SUBSURFACE SEWAGE DISPOSAL SYSTEM INSPECTION FORM
PART A
CERTIFICATION

JOB MANDLE SEPTIC - ADDENDUM
 SHEET NO. 1 OF 1
 CALCULATED BY A. Weiss DATE 2/14/95
 CHECKED BY (AW) DATE 4/25/95
 SCALE 1" = 40' (Revised 7/5/00)

RE: Septic System Repair & Variance Approval
Dian Mandle Residence, 351 Potwine Lane, Amherst, Ma.
Transmittal Form # 58599

PROPOSED SEPTIC REPAIR PLAN FOR DIAN MANDLE 351 POTWINE LA, AMHERST, MA.		
SCALE:	APPROVED BY:	DRAWN BY AW
DATE: 10/21/94		
COLD SPRING ENVIRONMENTAL, INC. BELCHERTOWN, MA. 323-5957		
DRAWING NUMBER		94-404-0822

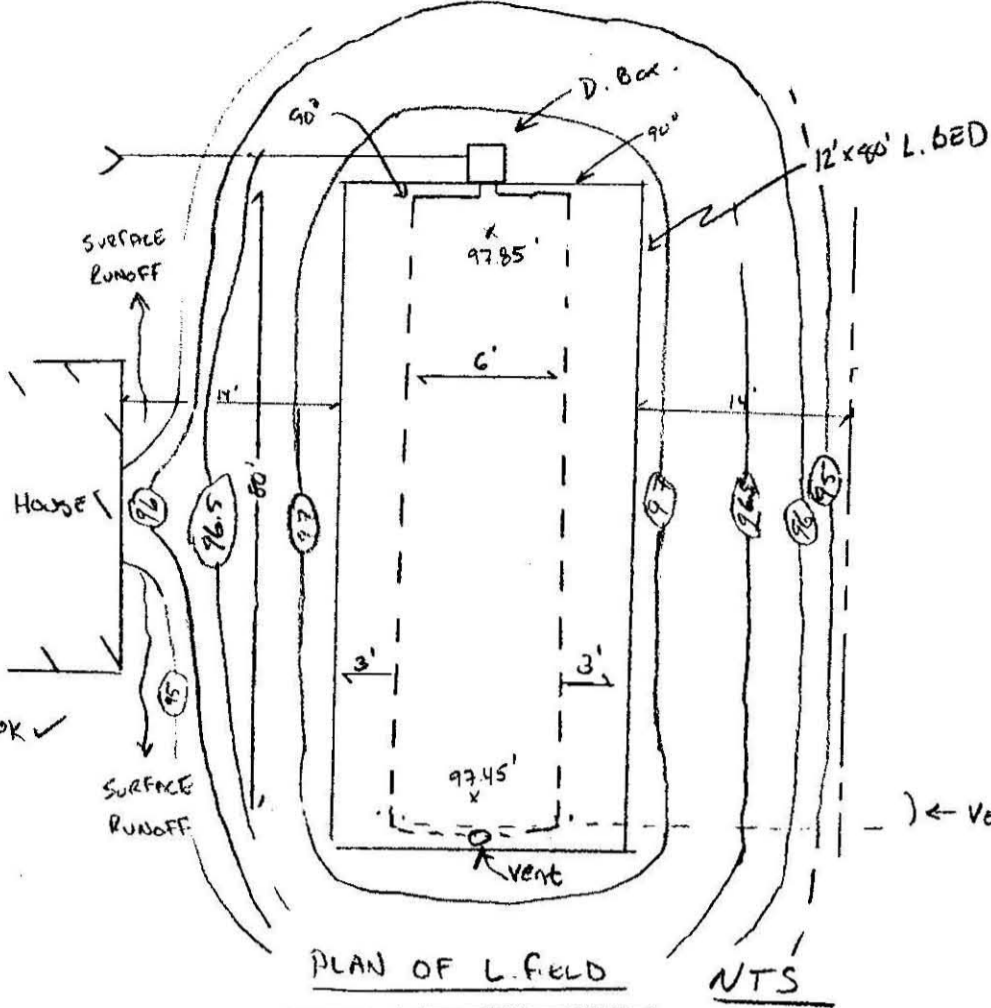
This septic is proposed to be changed without a pump and pump chamber as noted. The location and elevation of the septic remains the same. With piping exiting the rear of the house the system can gravity flow (a preferred option)
